REFERENCE: Docket 50-186  
University of Missouri-Columbia Research Reactor  
Renewed Facility Operating License No. R-103

SUBJECT: Written communication as specified by 10 CFR 50.4(b)(1) regarding responses to the  
"University of Missouri at Columbia - Request for Additional Information RE: License  
Amendment Request to Implement Selective Gas Extraction Target Experimental  
Facility at the University of Missouri Research Reactor (CAC No. MF9524)," dated  
September 7, 2017

By letter dated September 7, 2017, the NRC requested additional information and clarification regarding the proposed LAR in the form of thirty-eight (38) questions (numbered 1 through 38).

Below are MURR’s responses to the September 7, 2017 request for additional information, including enclosures of supporting documentation.

# 2S42

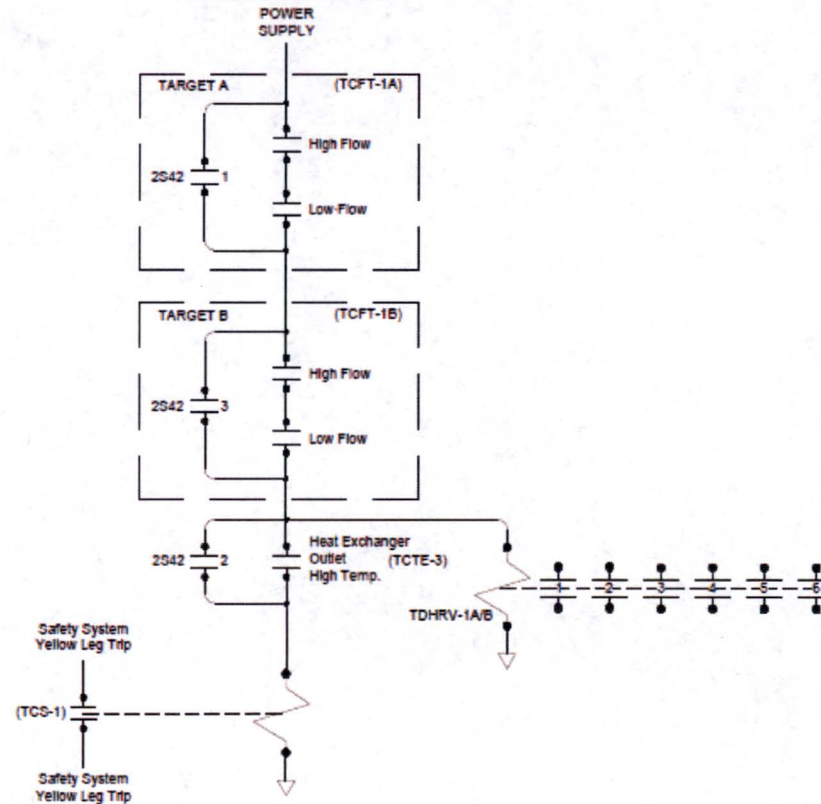
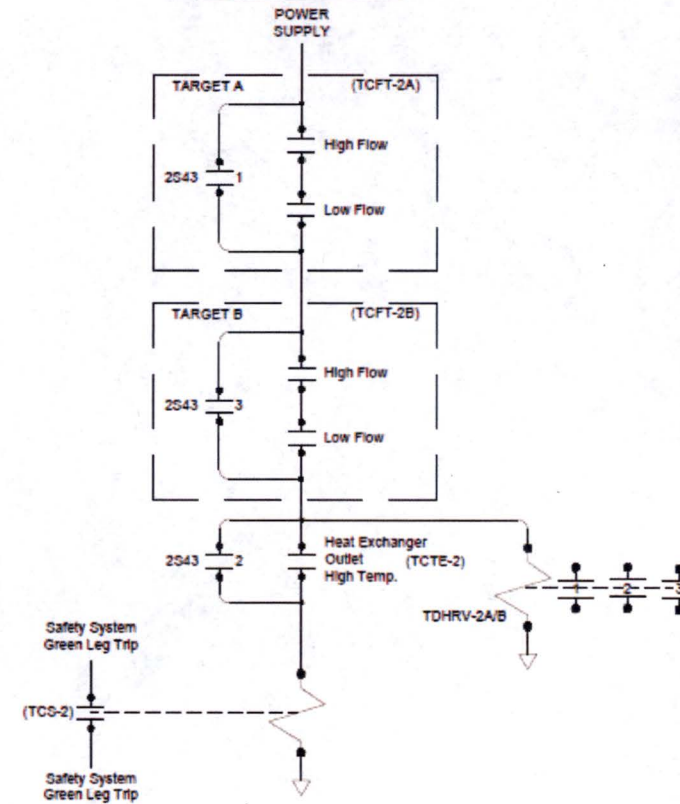
- 4.7. *The NRC staff review finds that the keyed bypass switches to the TCS Protection System (LAR, Attachment 1, Section 4.3.3, "Target Cooling System Protection Bypass Capability"), allow for reactor operation with the TCS not operating, one TCS branch operating, or both TCS branches operating. The keyed bypass removes the protection signal inputs for any part of the TCS that is not operating. However, the following information was not provided. Provide the following information or justify why no additional information is needed:*

First of all, there has been a change to the bypass switch design to the TCS protection system since the license amendment for this project was first submitted. MURR staff realized that using one (1) keyed bypass switch allowed a potential for a single failure to affect both the "Yellow" and "Green" legs of the safety system of the TCS protection system. Therefore, the design has changed to have two (2) independent keyed bypass switches; one switch for the "Yellow" safety leg and the other for

the “Green” safety leg. The revised design has no physical connection between the “Yellow” and “Green” safety legs and is represented by Figure 4.7.

As stated earlier, the keyed bypass switch design submitted with the original license amendment request did not have electrical isolation between the TCS "Yellow" and "Green" safety legs. However, the revised two (2) bypass switch design as shown in Figure 4.7 eliminates all electrical connections between the TCS "Yellow" and "Green" safety legs. Therefore, there is electrical isolation between the TCS "Yellow" and "Green" safety legs, the TCS safety legs and the MURR reactor safety system, and the MURR reactor safety system "Yellow" and "Green" safety legs. The only interaction between a TCS safety leg and the MURR reactor safety system is the magnetic coupling inside the associated relay (TCS-1 or

Figure 8-1  
Mass Flow Rate Details for LAR Attachment 1, Figure 84

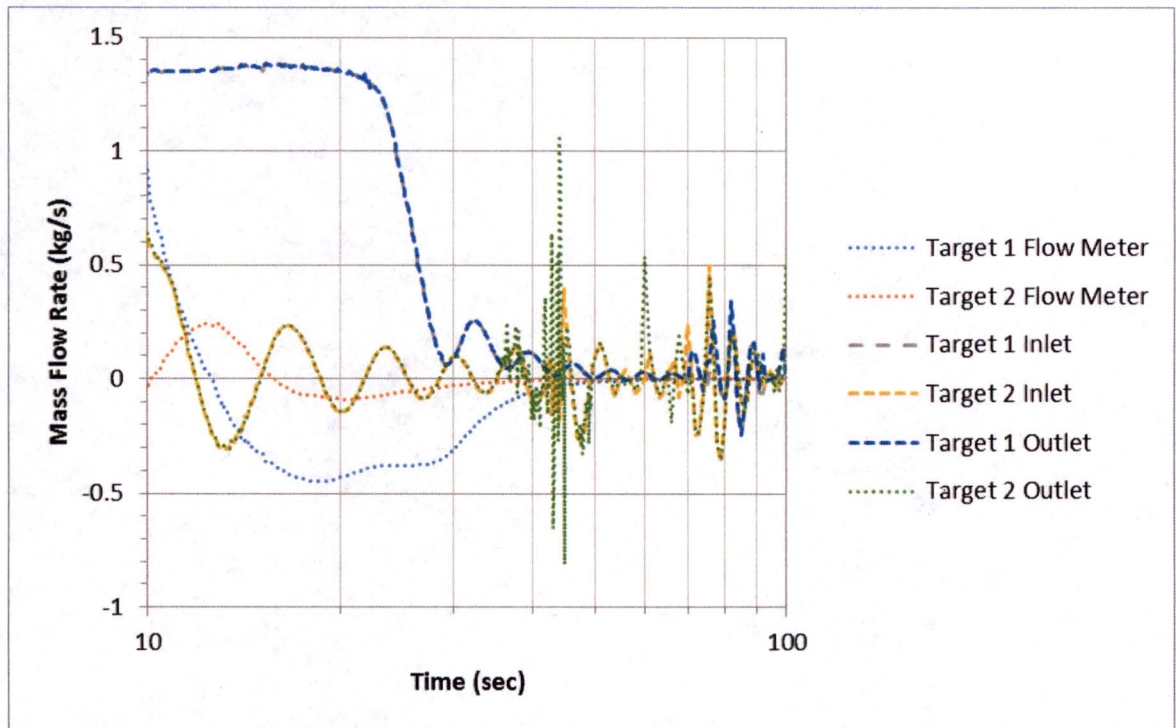
For the pipe break in air without the Target Decay Heat Removal Valves (TDHRVs) opening, Figure 84 in LAR, Attachment 1 needs additional explanation. During the break opening time, the TCS pump trip and early coastdown have a declining contribution to the overall flow through the Target Assembly (TA). After the break is completely open, water in the broken pipe above the reactor pool level slowly drains into and through TA 2. As the water head in the broken pipe decreases, the flow rate also decreases. After 10 seconds, TA 2 inlet and outlet flow rates go through an oscillation as the water level in the broken pipe achieves pressure equilibrium with the reactor pool. Void-induced chugging does not occur until 40 seconds, as indicated by the transition from oscillatory flow to more erratic spikes in TA 2 inlet and outlet flow rates during the early phase of the transient as shown in Figure 8-1 below. It should also be noted that the flow meters are not indicative of the flow rate through the TAs since they are located above the reactor pool and upstream of the break location. No counter current flow limitation (CCFL) was applied to this analysis. The application of CCFL is discussed in the response to RAI No. 8.2 below.

A counter current flow limitation (CCFL) was not used in the RELAP5 analyses in the LAR. The analysis discussed in RAI No. 8.1 above was repeated with a CCFL applied at the upper and lower target rod cartridges. The parameters in the RELAP5 model are as follows:  $b = 0$ ,  $m = 1$ , and  $c = 0.725$  for sharp edges, which will be the case for the TA. The CCFL had minor effects on the analysis. When high void fractions occurred after 40 seconds, TA 2 inlet and outlet flow rates, outlet temperature, and cladding temperature agreed within 10% with the case reported in LAR, Attachment 1, Section 10.5.

Figure 12-1  
RELAP5 and Experimental Results for Pump Coastdown

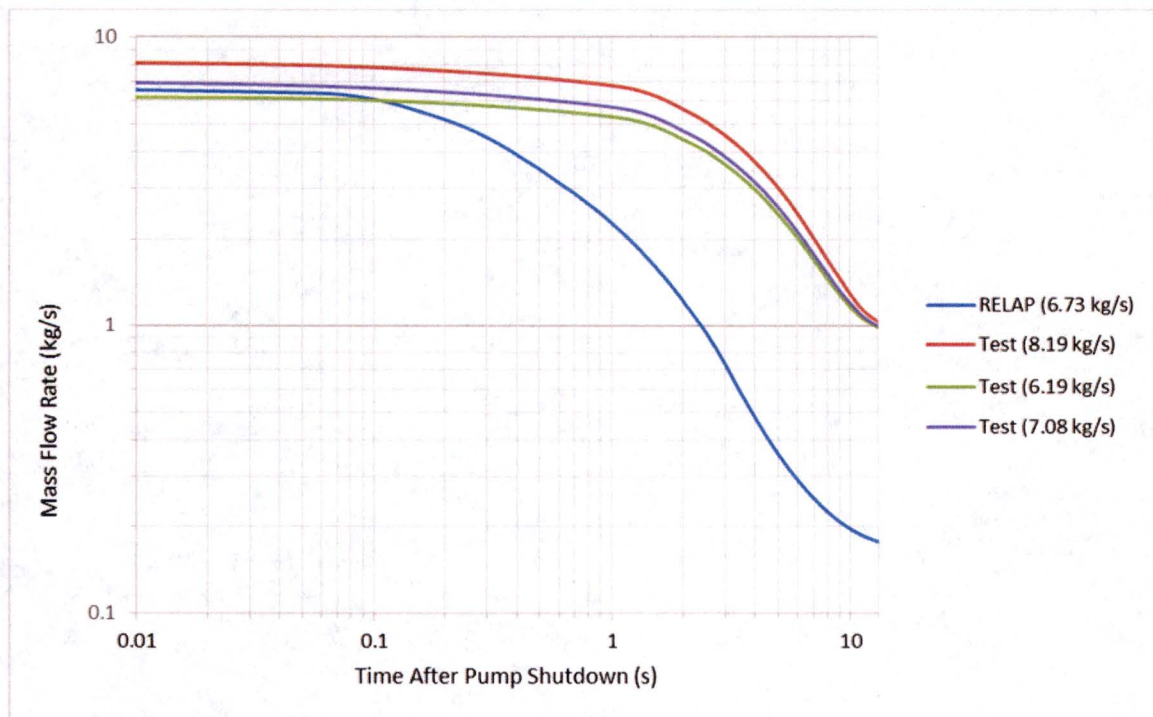
For these cases, the Target Decay Heat Removal Valves do not open. Results for the flow rate versus time after loss of pump power for the tests as well as for RELAP5 are shown in Figure 12-1. As shown in the figure, the flow rate for the RELAP5 calculation reduces more quickly during a pump coastdown than what was observed in the tests, even for the test case with increased margin on the pressure drop. The RELAP5 modeling of the pump is therefore determined to be conservative, as the reduced flow shortly after pump shutdown causes a faster reduction in heat transfer, leading to higher temperatures.

The target system flow tests documented in Reference 12-1 show that the RELAP5 model presented in the LAR is conservative with respect to the pressure drop in the TA, as well as for the pump coastdown model.

Figure 29-1  
SGE Target Rod Temperature Segments

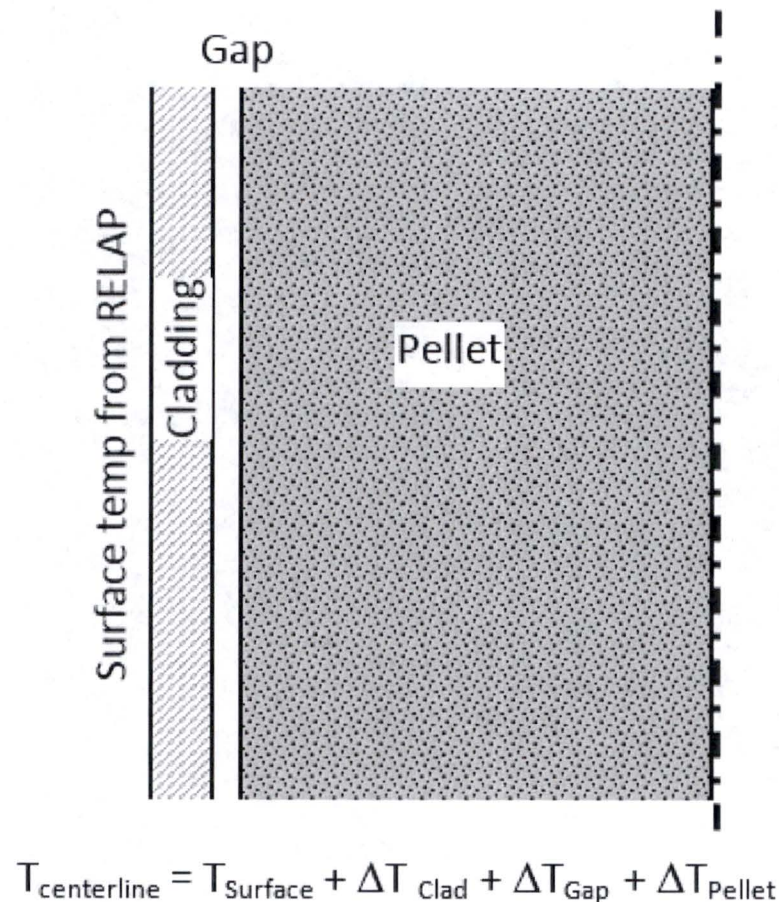
General Atomics' (GA) recognizes that the FRAPCON fuel rod performance data covers Linear Heat Generation Rates (LHGR) up to 43.7 kW/m and maximum measured centerline temperatures up to approximately 1850 °C (3362 °F) [Ref. 29-1, Figure 3.1]. The performance of the SGE target rods exceeds these validation bases in the following three (3) respects:

The cladding surface temperature of the target rod is a fixed boundary condition provided by RELAP. Therefore, the temperature buildup to the  $\text{UO}_2$  centerline consists of three (3)  $\Delta T$  segments for cladding, gap and pellet radius, as shown in Figure 29-1. Of these, the Zircaloy-4 cladding temperatures are well within the validated range of FRAPCON.

Figure 32-1  
Mass Flow Rates during a Loss of Coolant Accident  
before the Wye without Target Decay Heat Removal Valves

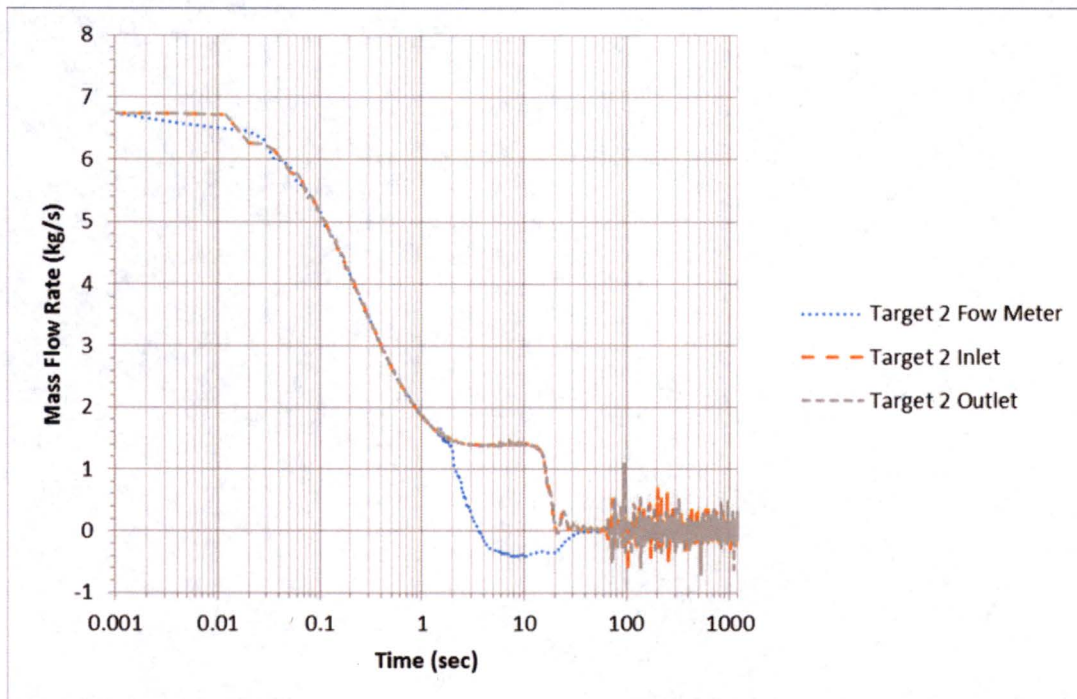
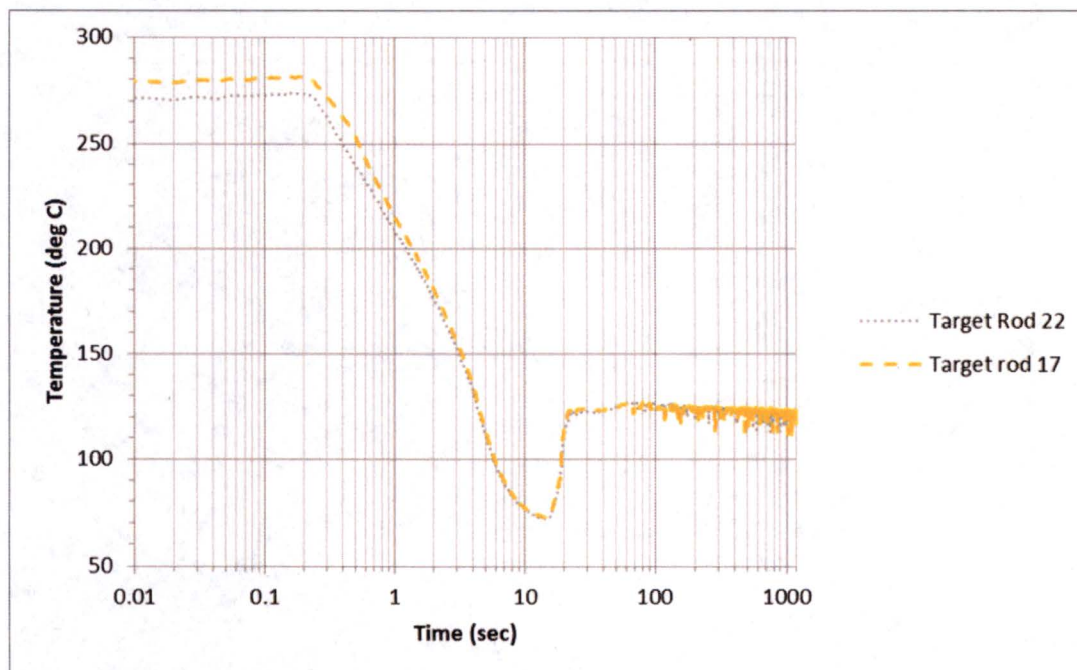
For the final design of the TCS, one additional break location was analyzed which was not reported in either LAR, Attachment 1 or Attachment 7. This break location is before the wye where the TCS splits in two and provides cooling to two (2) TAs. The water in the broken pipe provides an additional 10 seconds of target water flow compared to the break in one line close to the reactor pool as shown in Figure 32-1. Cladding temperatures during the boiling and chugging flow remain essentially the same since they are determined by water saturation temperature as shown in Figure 32-2. No other break sizes or break opening times were analyzed for the LAR. Additional analyses were performed in response to RAI No. 32.2 and No. 32.3 below.

Figure 32-3  
Cladding Temperatures vs. Pipe Break Times

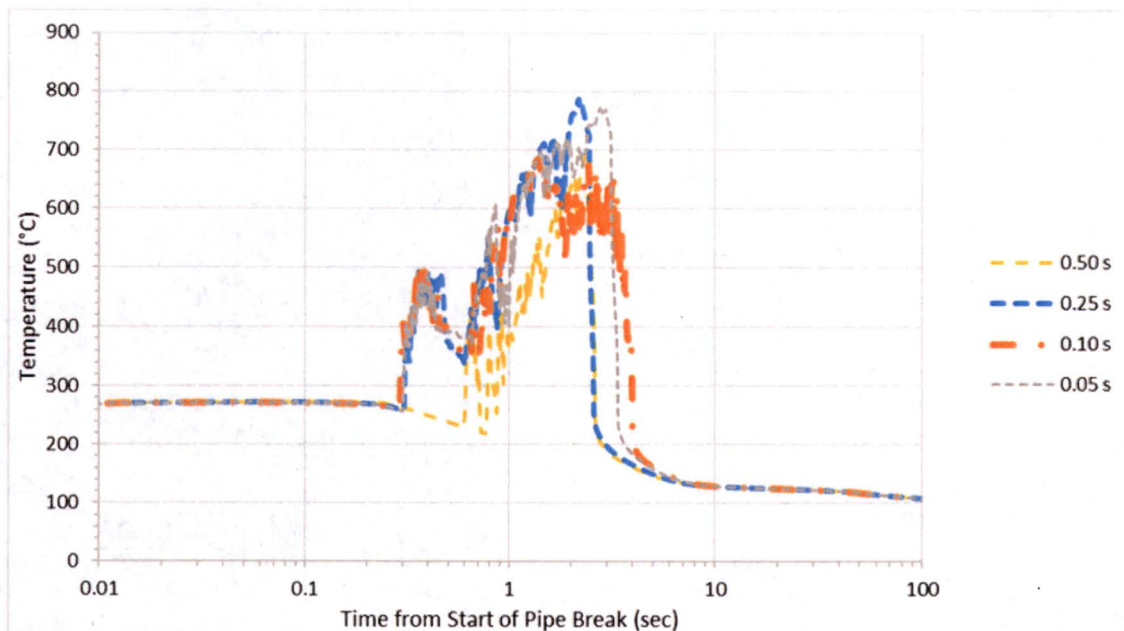
32.2. *The limiting LOCA scenario provided is a full double ended break at the inlet to the target fuel assembly. The calculation assumes a rupture time of 0.5 seconds. The NRC staff needs additional information to evaluate the system response. Provide sensitivity calculations showing the system response with assumed rupture times of 0.25, 0.1, and 0.01 seconds, or justify why no additional information is needed.*

Fluid momentum within the TA, along with boiling and chugging when the flow approaches zero, are able to keep peak cladding temperatures below 900 °C (1652 °F) until natural circulation flow through the break can be established, as shown in Figure 32-3 below.

Figure 33-1  
Pump Rotational Speed vs. Time – 0.1-Second Pump Seizure

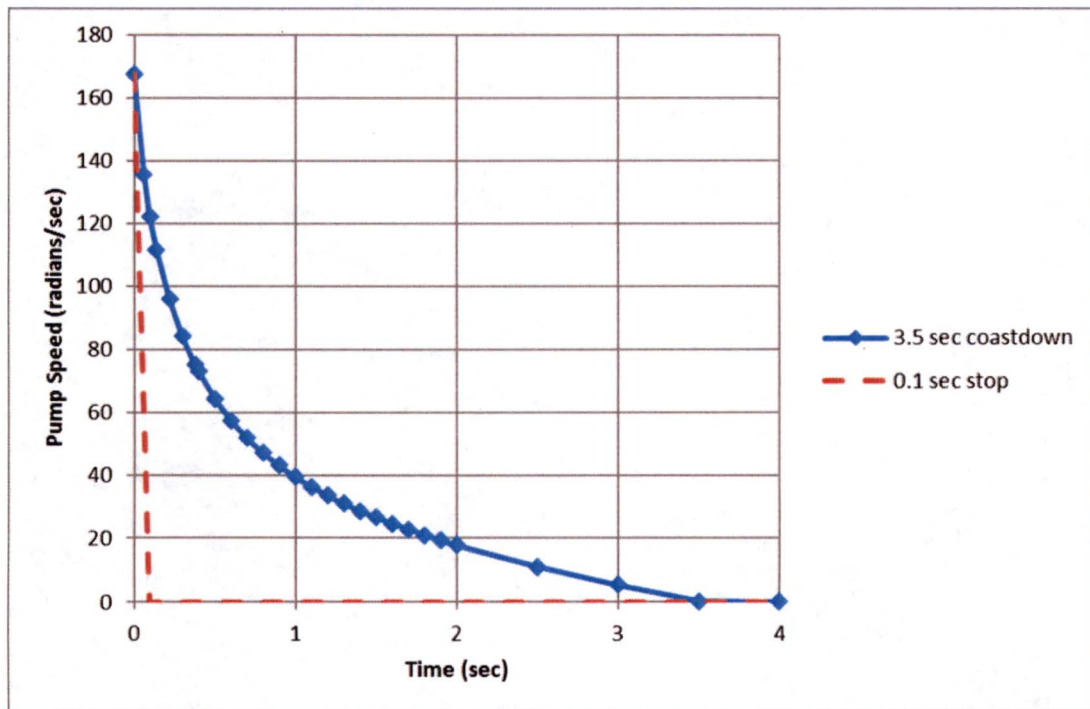
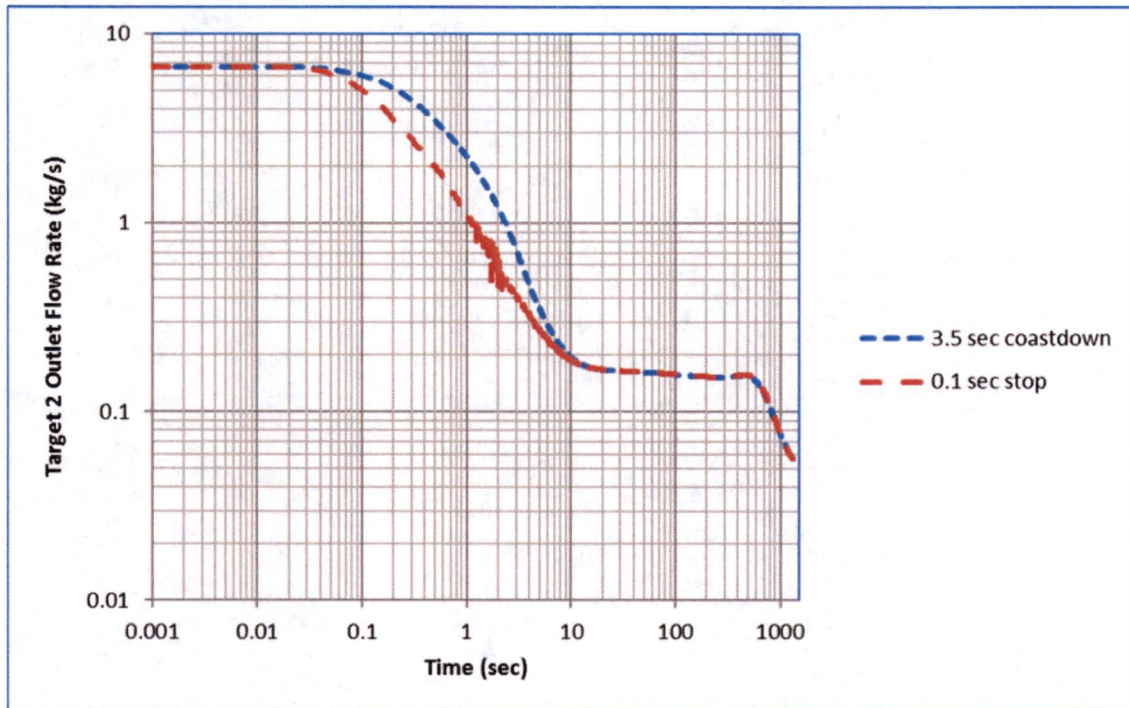
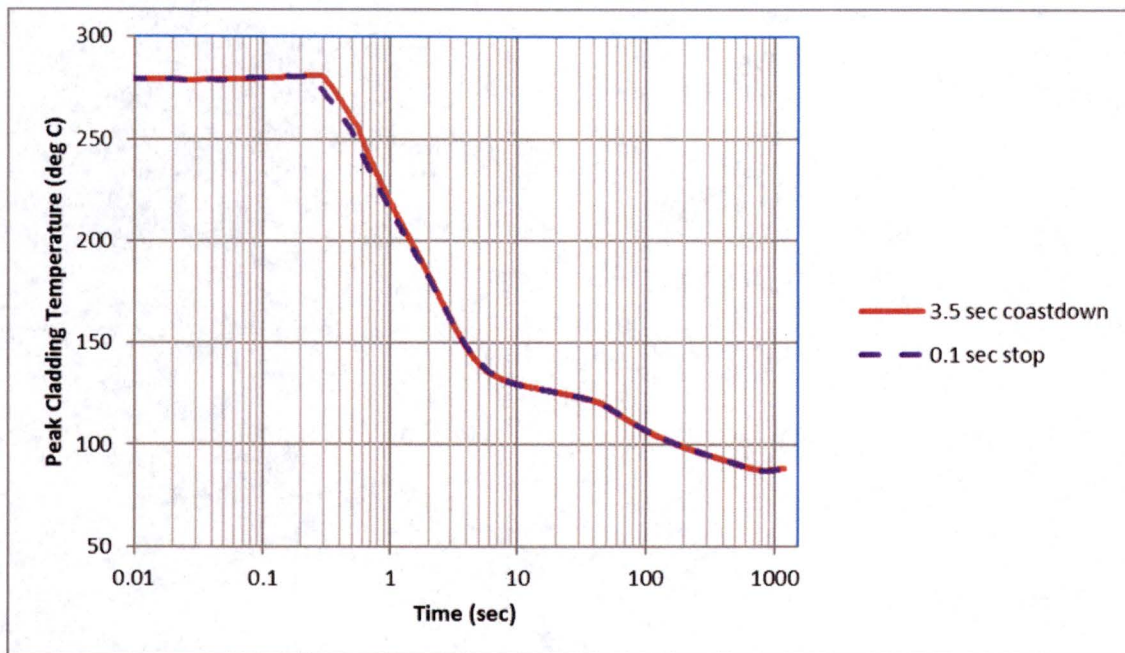
32.3. *Provide a description or analysis of any review of potential break sizes less than a full double ended break to establish the bounding break condition, or justify why no additional information is needed.*

The pump model in RELAP5 gradually reduces in speed within 3.5 seconds. Additional RELAP5 analyses were performed to examine more rapid reduction in flow in which the pump speed was reduced to zero within 1.0, 0.5, and 0.1 seconds. The results for the 0.1-second pump stoppage are presented since they are the most limiting. Figure 33-1 below compares the RELAP5 pump coastdown profile with the 0.1-second pump seizure.

The mass flow rate for the 0.1-second case exiting Target Assembly 2 (also referred to as TA 'B' in the LAR) decreases by a factor of two (2) at 1 second, compared to the 3.5-second case, and shows some flow instability after that time. This flow instability is due to boiling and void generation, which is calculated to be less than 3%. Fluid momentum and natural circulation through the stopped pump provide sufficient flow to keep the target rods cooled as shown in Figures 33-2 and 33-3. Peak cladding temperature during the transient remains essentially unchanged.
